PECOS DISTRICT CONDITIONS OF APPROVAL

OPERATOR'S NAME:	COG Operating LLC
LEASE NO.:	NMLC-064150
WELL NAME & NO.:	Nelson South Federal #3
SURFACE HOLE FOOTAGE:	0330' FSL & 0330' FWL
LOCATION:	Section 10, T. 17 S., R 32 E., NMPM
COUNTY:	Lea County, New Mexico

Cross Section of a Typical Lead-off Ditch

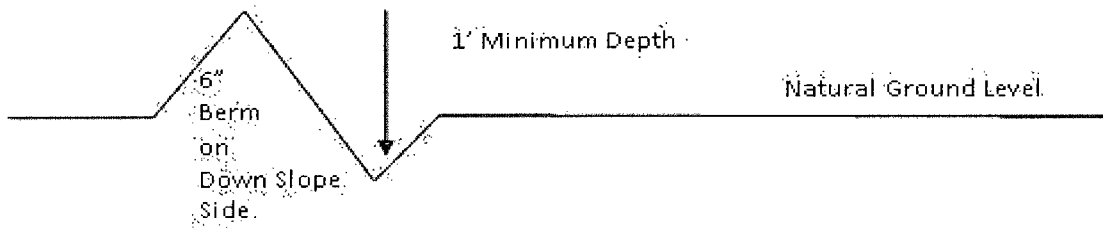
A typical lead-off ditch has a minimum depth of 1 foot below and a berm of 6 inches above natural ground level. The berm shall be on the down-slope side of the lead-off ditch.

All lead-off ditches shall be graded to drain water with a 1 percent minimum to 3 percent maximum ditch slope. The spacing interval are variable for lead-off ditches and shall be determined according to the formula for spacing intervals of lead-off ditches, but may be amended depending upon existing soil types and centerline road slope (in %);

Figure 1 – Cross Sections and Plans For Typical Road Sections

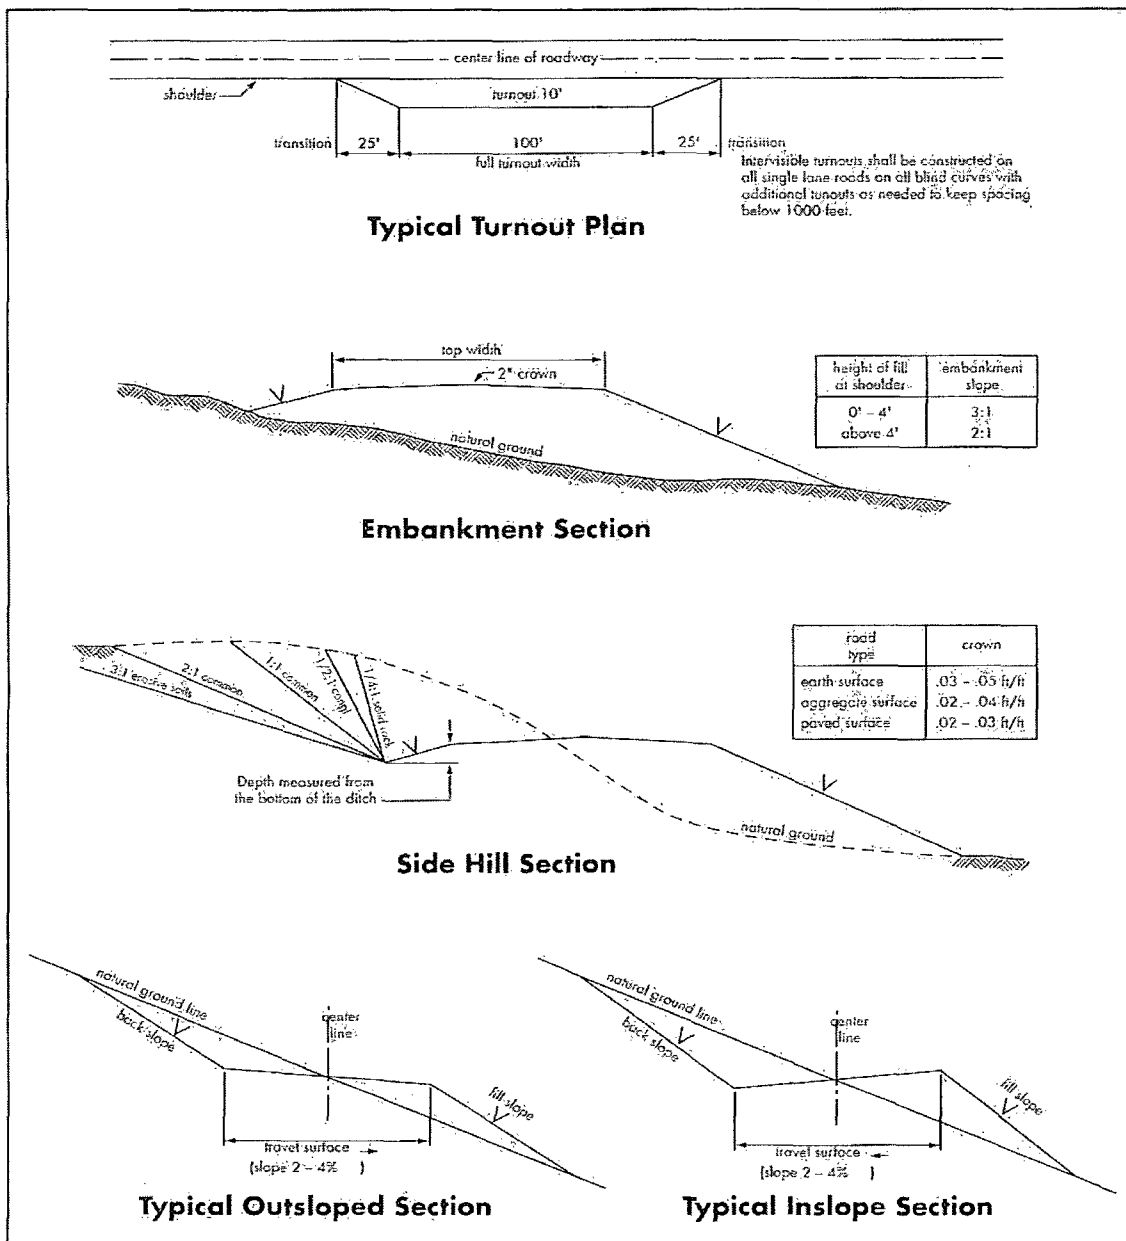
Crowning shall be done on the access road driving surface. The road crown shall have a grade of approximately 2% (i.e., a 1" crown on a 14' wide road). The road shall conform to Figure 1; cross section and plans for typical road construction.
